June 14, 2024

RE: Federal Motor Vehicle Safety Standards; FMVSS No. 305a Electric-Powered Vehicles: Electric Powertrain Integrity Global Technical Regulation No. 20, Incorporation by Reference.

Appendix 1

Additional Clarification Questions and Proposed Regulatory Text Changes

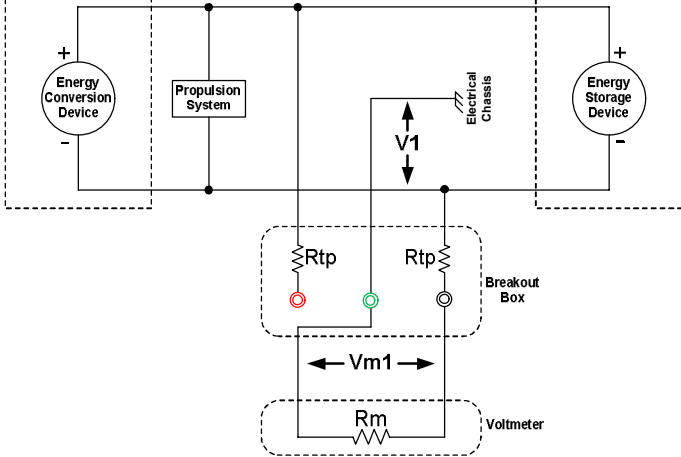
Section number	Comments and suggested redline edits on the proposed regulatory text
S 4. Definitions	Parking mode – the statement of “vehicle power is turned off” can be ambiguous. Is the agency referring to HV power (or motive power) is off? Or that all power is turned off? This may be relevant for any required actions to be taken while in parking mode.
S6.4	We recommend remove requirements for AVs without manual driving controls; NHTSA has not provided rationale for why any warning needs to be provided to the “front row occupant”; the occupant cannot take any action based on the visual warning.
S7.1.2	We propose NHTSA revise S7.1.2 as follows: <u>Voltage Vb is the voltage across the two terminals of the voltage source as shown in Figure 1. Voltage Vb is measured through a safety breakout box with inline resistors that reduce the maximum possible current exposure to a level safe for human contact. One inline resistor of the resistance value Rtp is between the testing access point and the positive side of the high voltage source. Another inline resistor of the resistance value Rtp is between the testing access point and the negative side of the high voltage source. The internal resistance of the voltmeter is Rm. The reading of the voltmeter connected to the two testing access points is Vmb. Voltage Vb is determined by the formula in Figure 1. Voltage Vb is measured across the two terminals of the voltage source.</u> Before a vehicle crash test, Vb is equal to or greater than the working voltage as specified by the vehicle manufacturer. <u>This calculation formula should be used when installing Rtp in the safety breakout box.</u> Note: If the access point used does not include inline resistors to reduce potential current exposure levels, 0 should be substituted for Rtp in all formulas. The text and corresponding diagram in Figure 1 should also be revised as follows:

Section number	Comments and suggested redline edits on the proposed regulatory text
	$V_b = (1 + 2R_{tp}/R_m)V_{mb}$ Figure 1. Voltage Measurements of the High Voltage Source. Measurement for V_b Voltage Between the Positive Side of the High Voltage Source and the Negative Side of the High Voltage Source through a Safety Breakout Box with Inline Resistors.
S7.1.3	We propose NHTSA revise S7.1.3 as follows: Voltage V1 is measured between the negative side of the high voltage source and the electrical chassis as shown in Figure 2. Voltage V2 is measured between the positive side of the high voltage source and the electrical chassis as shown in Figure 3. Voltage V1 is the voltage between the negative side of the high voltage source and the electrical chassis as shown in Figure 2. Voltage V1 is measured through a safety breakout box with inline resistors. The reading of the voltmeter connected to the two testing access points is V_{m1}. Voltage V1 is determined by the formula in Figure 2. Voltage V2 is the voltage between the positive side of the high voltage source and the electrical chassis as shown in Figure 3. Voltage V2 is measured through a safety breakout box with inline resistors. The reading of the voltmeter connected to the two testing access points is V_{m2}. Voltage V2 is determined by the formula in Figure 3. The text and corresponding diagram in Figure 2 should also be revised as follows:

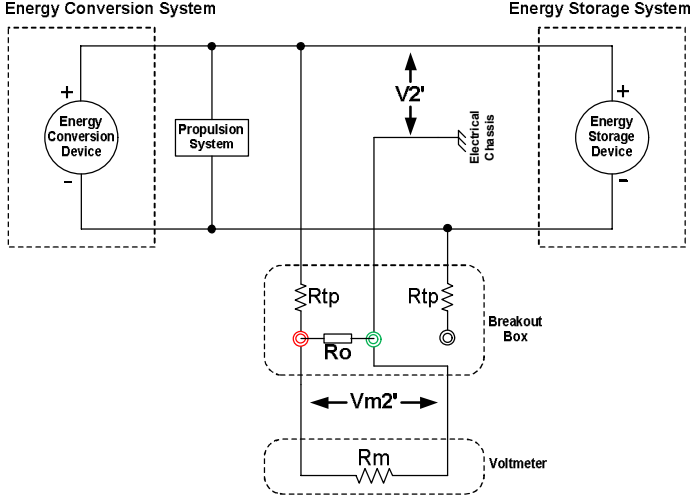
Section number	Comments and suggested redline edits on the proposed regulatory text
	Energy Conversion System Energy Storage System  $V1 = (1 + R_{tp}/R_m)V_{m1}$ Figure 2. Measurement for V1 Voltage Between the Negative Side of the High Voltage Source and the Electrical Chassis <u>through a Safety Breakout Box with Inline Resistors.</u> The text and corresponding diagram in Figure 3 should also be revised as follows: Energy Conversion System Energy Storage System  $V2 = (1 + R_{tp}/R_m)V_{m2}$ Figure 3. Measurement for V2 Voltage Between the Positive Side of the High Voltage Source and the Electrical Chassis <u>through a Safety Breakout Box with Inline Resistors.</u>
S7.2.1	We propose NHTSA revise S7.1.3 as follows: If V1 is greater than or equal to V2, insert a known resistance (Ro) between the negative side of the high voltage source and the electrical chassis. With the Ro

Section number	Comments and suggested redline edits on the proposed regulatory text
	 $V2' = (1 + R_{tp}/R_o + R_{tp}/R_m)V_{m2'}$ $R_i = (R_o + R_{tp})(1 + V_1/V_2)((V_2 - V_2')/V_2')$ Figure 5. Measurement for V2' Voltage Across Resistor Between Positive Side of the High Voltage Source and Electrical Chassis. Measurement for V2' Between Positive Side of the High Voltage Source and the Electrical Chassis When a Known Resistor Ro is Inserted Through a Safety Breakout Box with Inline Resistors.
S7.5	This provision is inconsistent with ECE practice where the energy of a Y capacitor is the greater of $0.5C_y \times V_{11}^2$ or $0.5C_y \times V_2^2$; adopt the same method for determining the energy of a Y capacitor as ECE 100.03.
S8.2	Revise text to clarify that low electrical energy post-crash is an option. After each test specified in S9 of this standard, each high voltage source in a vehicle must meet one of the following electrical safety requirements: electrical isolation requirements of subparagraph (a), the voltage level requirements of subparagraph (b), or the physical barrier protection requirements of subparagraph (c). High voltage capacitors in the electric power train may also meet electrical safety requirements using the low-energy requirements of subparagraph (d). We proposed NHTSA update the proposed regulatory text as follows: After each test specified in S9 of this standard, each high voltage source in a vehicle must meet one of the following electrical safety requirements: electrical isolation requirements of subparagraph (a), the voltage level requirements of subparagraph (b), or the physical barrier protection requirements of subparagraph (c), or the low-energy requirements of subparagraph (d).
